SUBJECT: STAFF RESPONSE TO WILLIAM H. WARD'S LETTER ON
SEISMIC ISSUES AT WOLF CREEK

STAFF RESPONSE TO WILLIAM H. WARD'S LETTER ON
SEISMIC ISSUES AT WOLF CREEK

SUBJECT: SITE SPECIFIC GROUND RESPONSE SPECTRA FOR SEP PLANTS
LOCATED IN THE EASTERN UNITED STATES

Figure 3

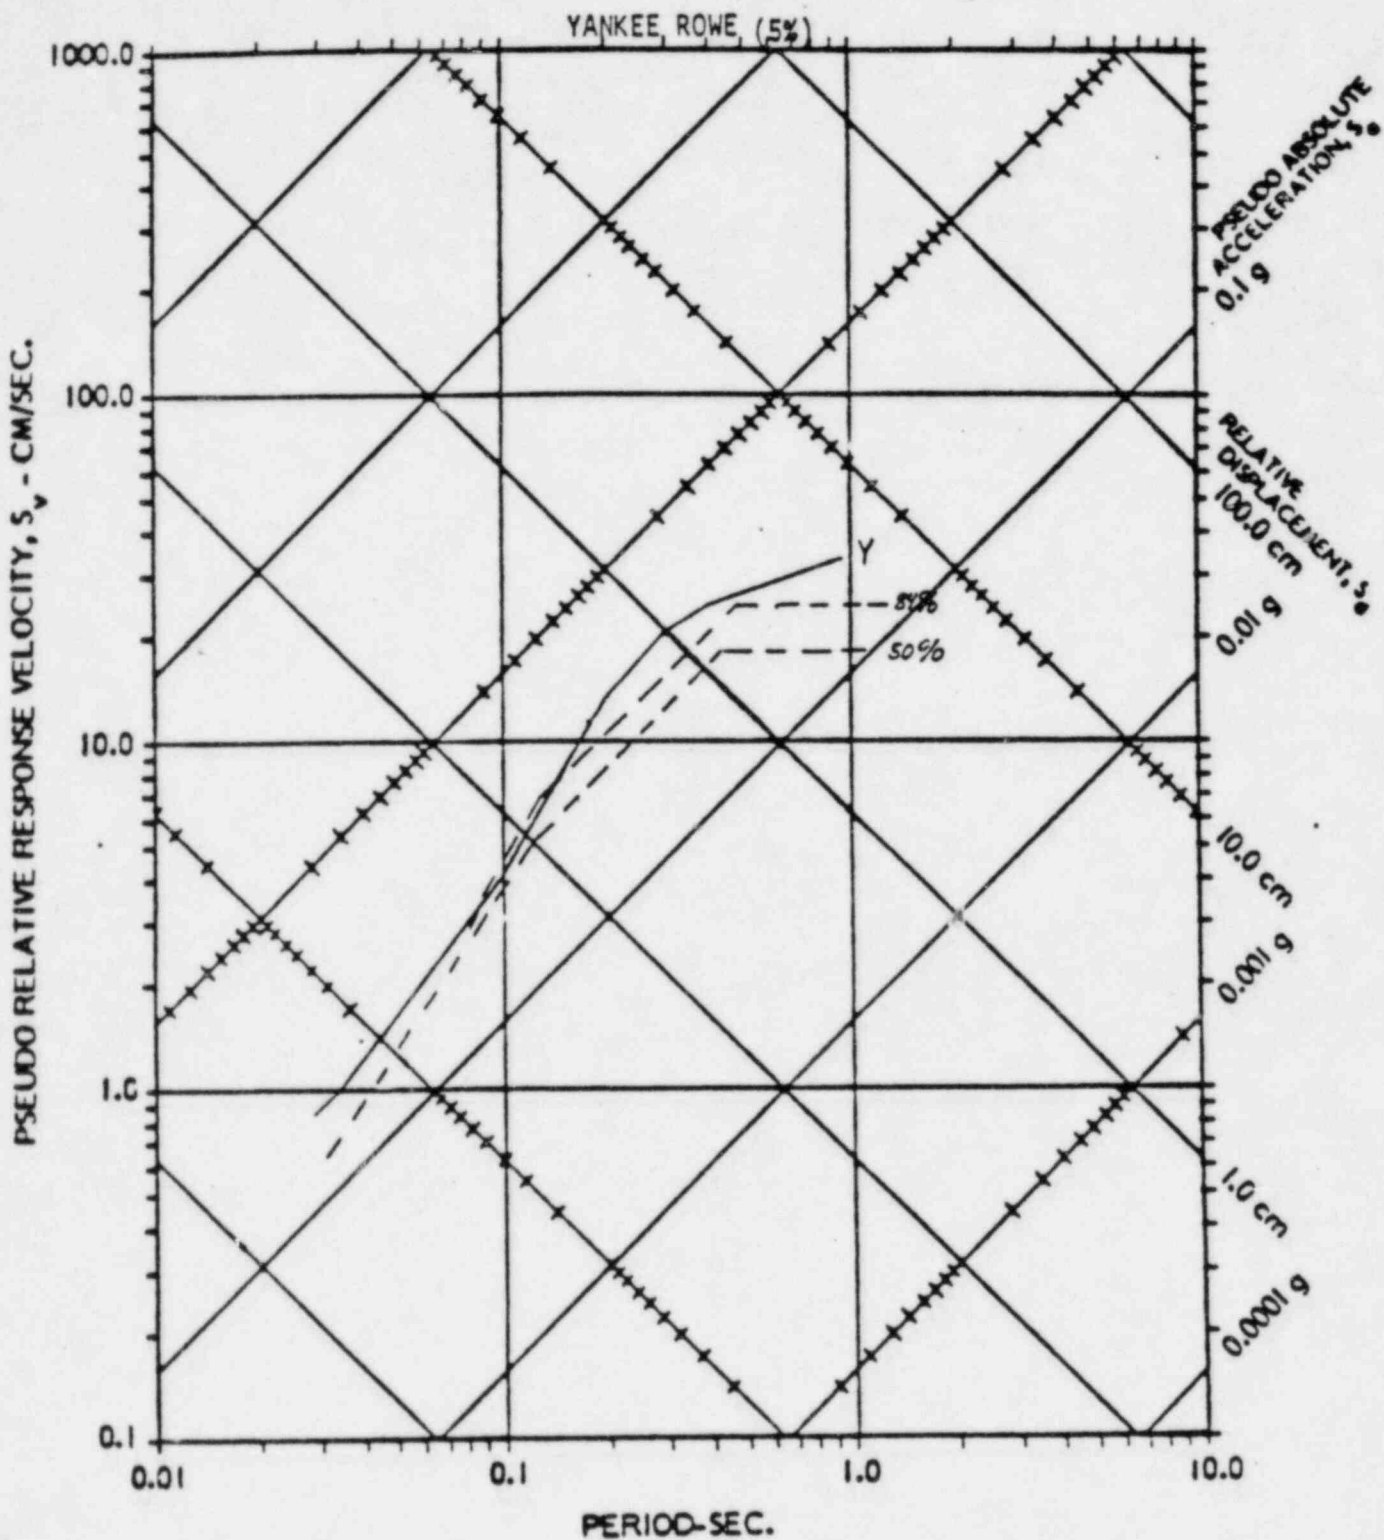
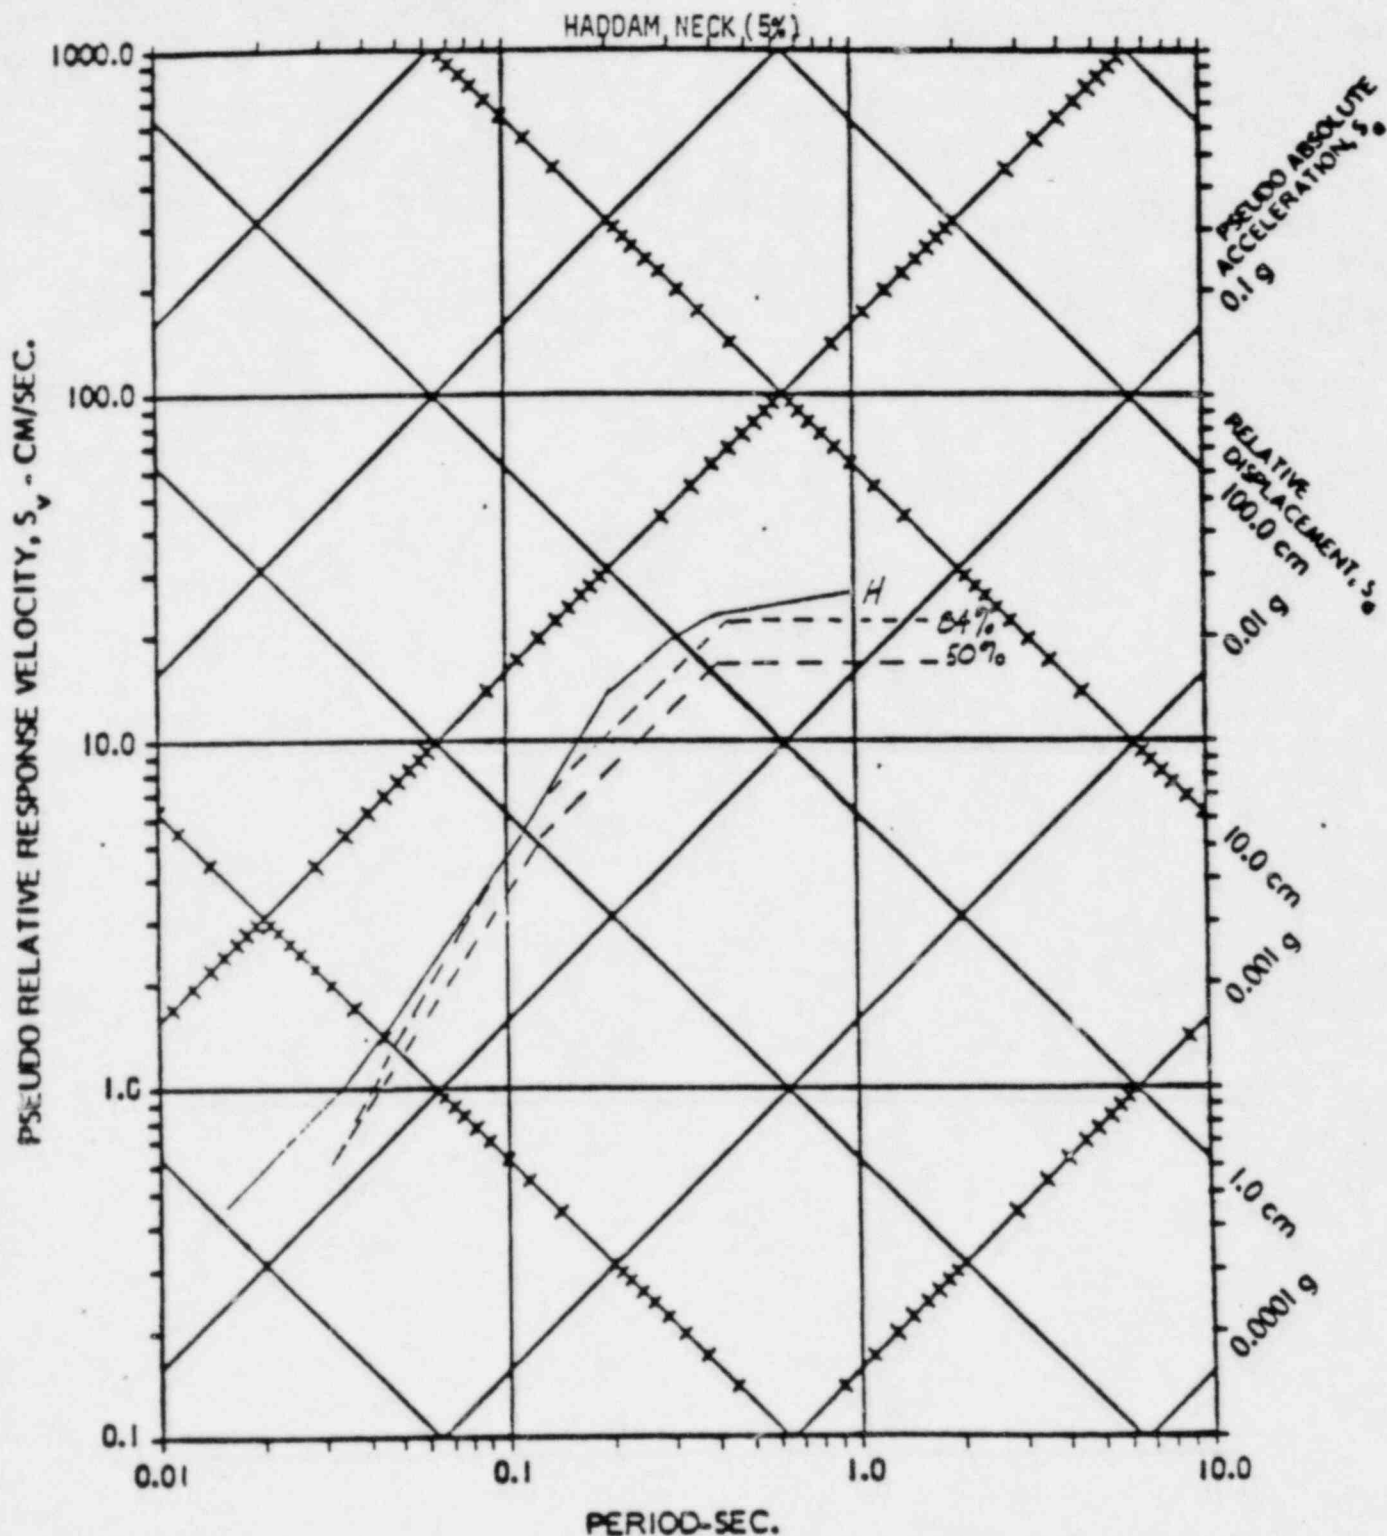
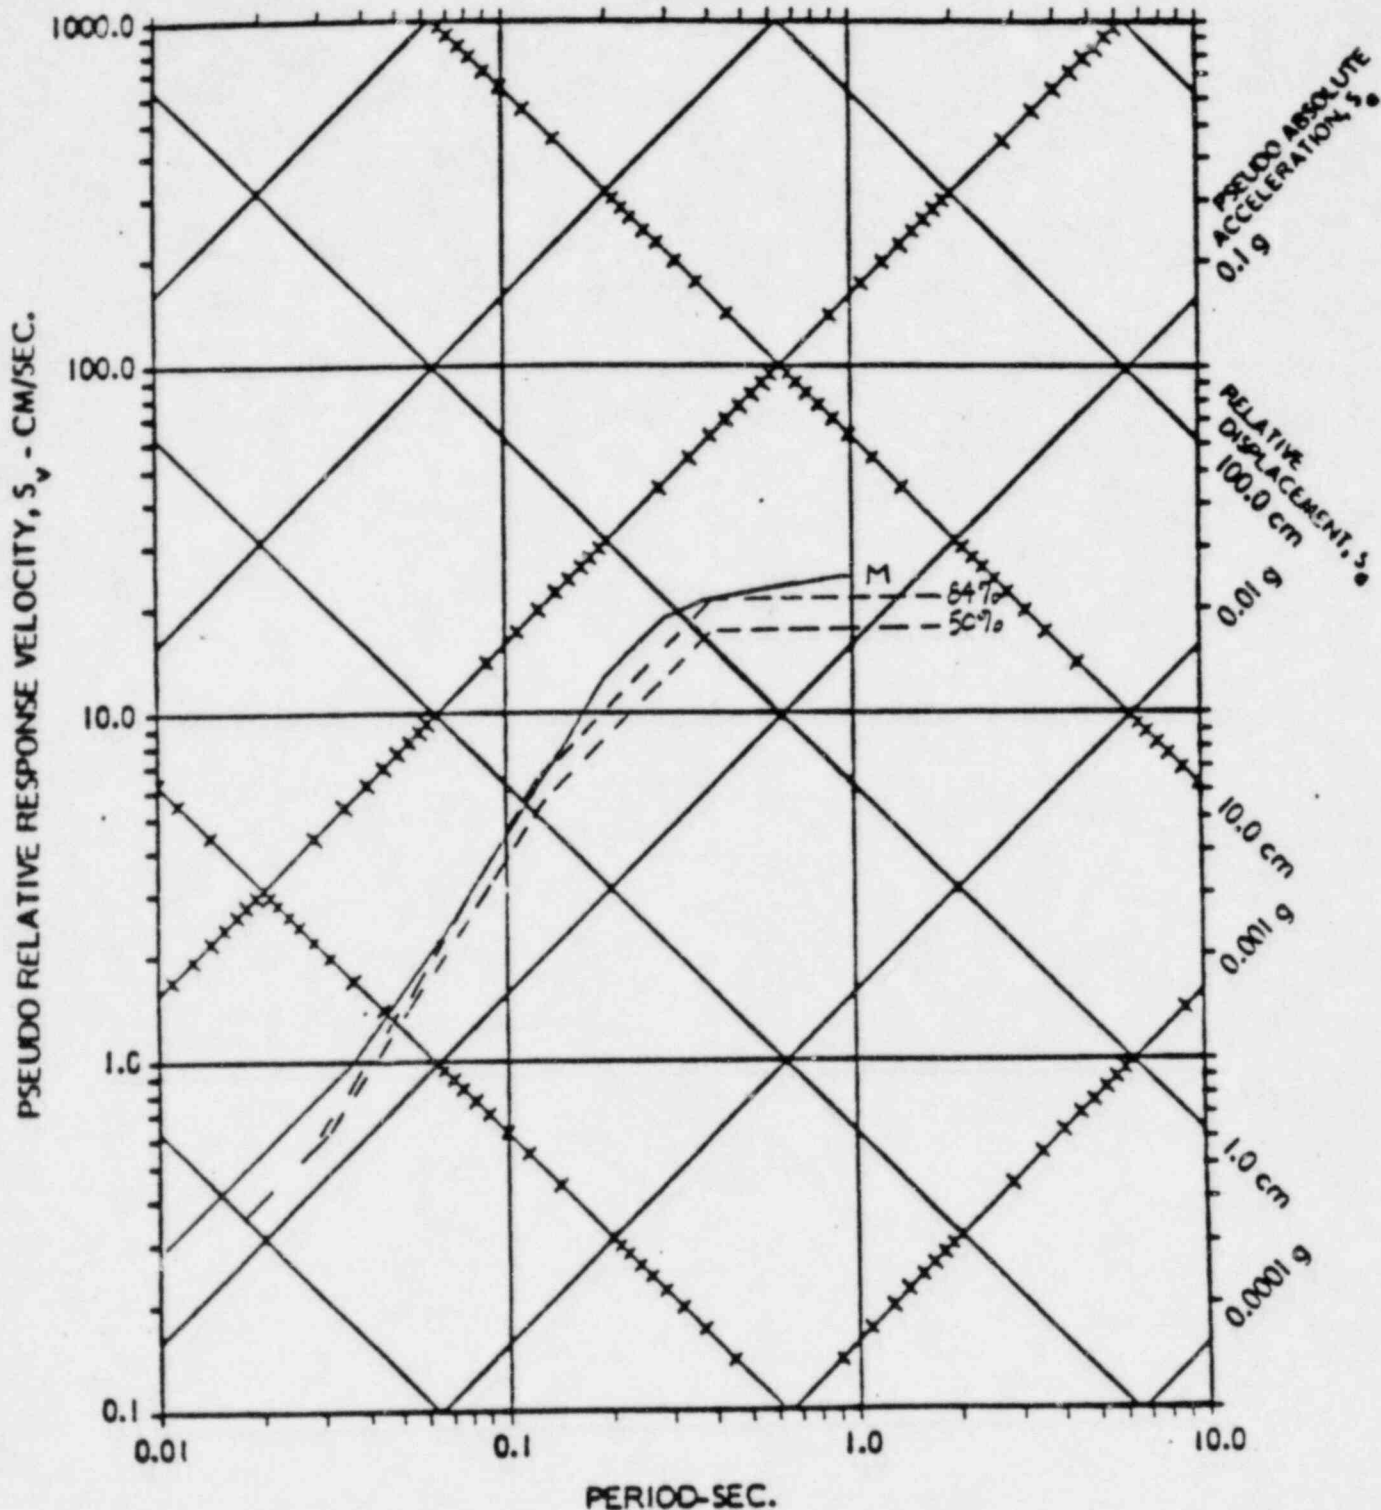
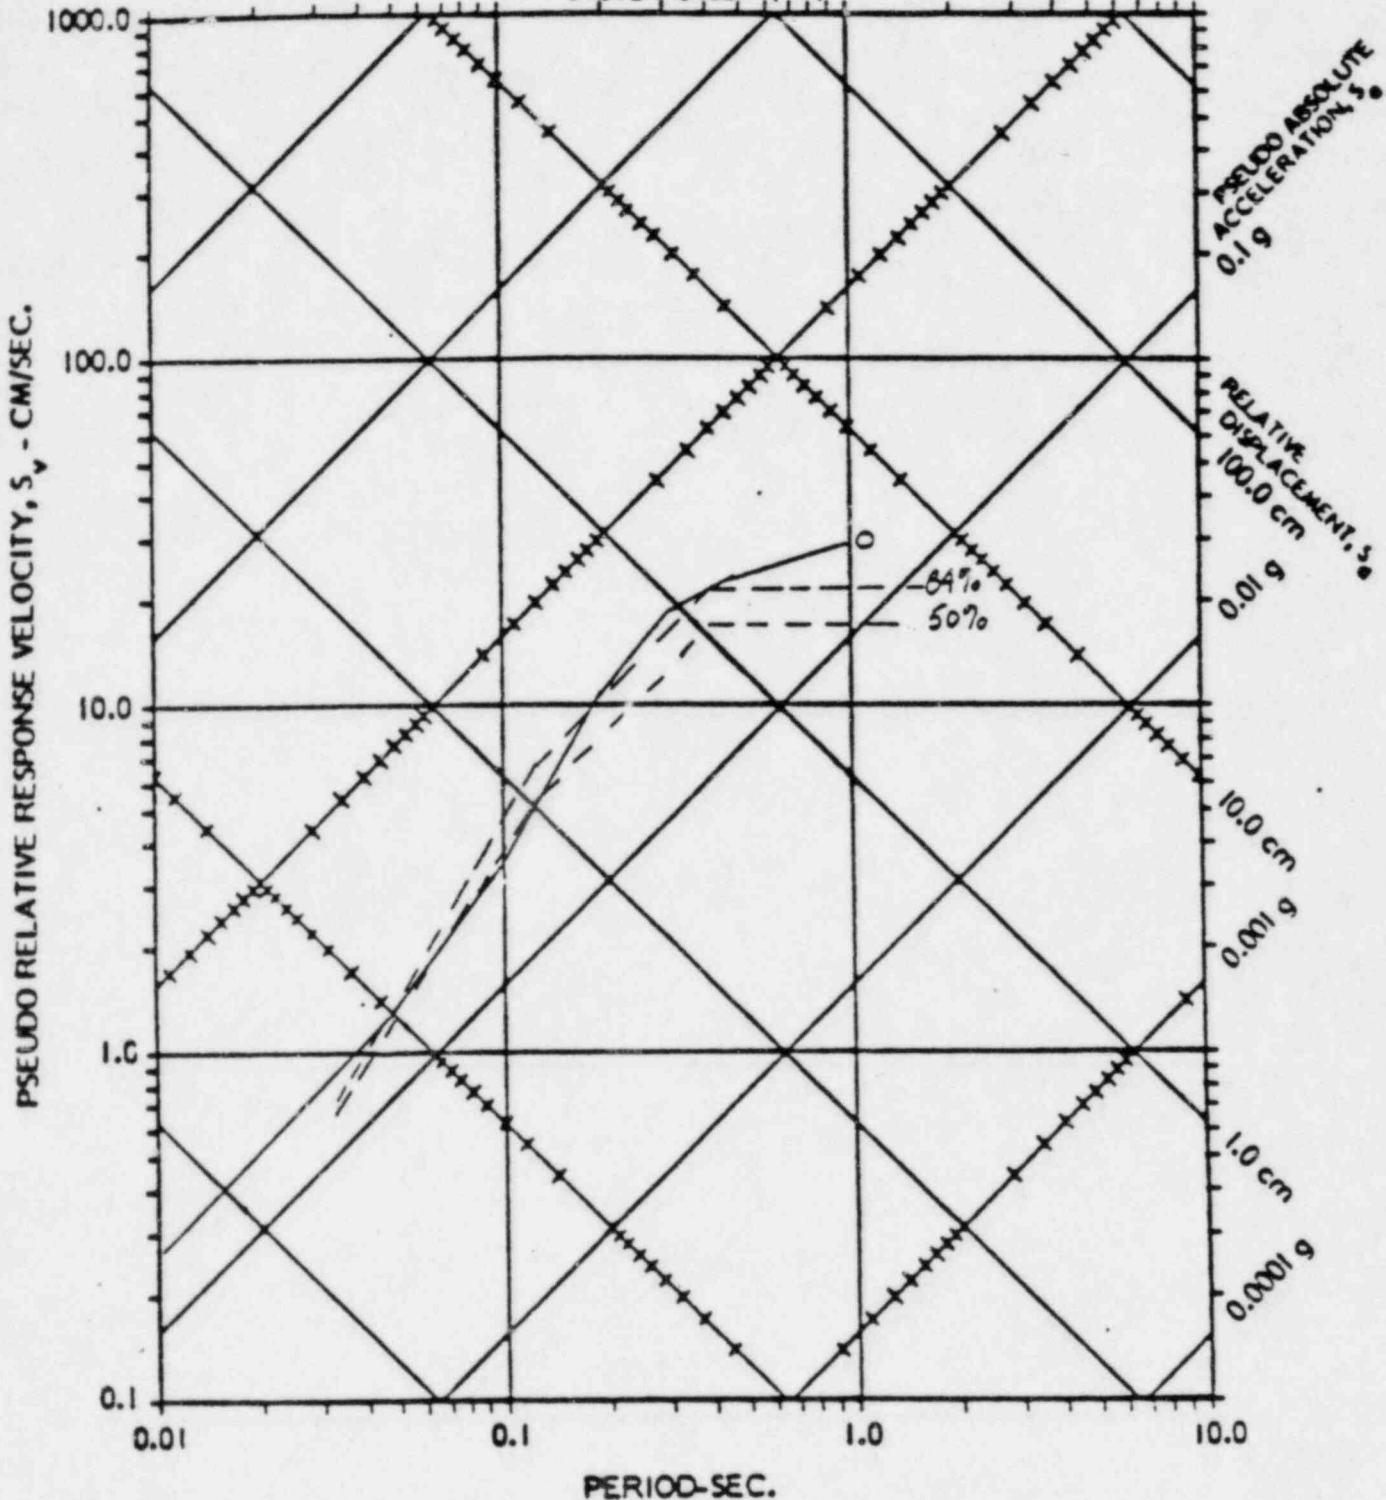
The deterministic peak accelerations and velocities are converted to response spectra using the amplification factors suggested by Newmark and Hall in NUREG CR-0098. Figs. 3 thru 11 compare the recommended uniform hazard spectra with 50th and 84th percentile deterministic spectra. In the central U.S. the recommended spectra generally fall below or at the 50th percentile. In the eastern United States the uniform hazard spectra are approximately

equivalent to the 84th percentile deterministic spectra. While the deterministic peaks are generally lower than the predicted peaks, use of the 84th percentile amplification factors usually more than compensate for the differences. Again the uniform hazard spectra more adequately reflect perceived relative hazard. The "tectonic province" approach can be made to achieve conservatism in this case by utilizing conservative amplification factors. Figures 12 and 13 show the uniform spectra compared to Reg. Guide 1.60 spectra anchored at 0.1 and 0.2g. Following suggested Standard Review Plan procedures for new plants that is utilizing the trend of the means of Trifunac and Brady (1975) to anchor the Reg. Guide 1.60 spectra, would result in design spectra anchored at between 0.12 and 0.20g. The specific acceleration used would depend in large part upon the applicants submittal and the reviewer's conservatism. For the central U. S. the recommended spectra are mostly below the Reg. Guide spectrum anchored at 0.1g while for eastern U. S. the recommended spectra are at or above the Reg. Guide spectrum anchored at 0.1g. The average recommended spectrum would be roughly equivalent to the Reg. Guide 1.60 Spectrum anchored at a peak acceleration of about 0.1g. The observation that the average peak acceleration associated with the recommended spectra (Table 2) is about 0.15g illustrates the often discussed conservatism of the Reg. Guide spectrum. It was conservatively derived from earthquakes of different sizes recorded at different distances and different site conditions.
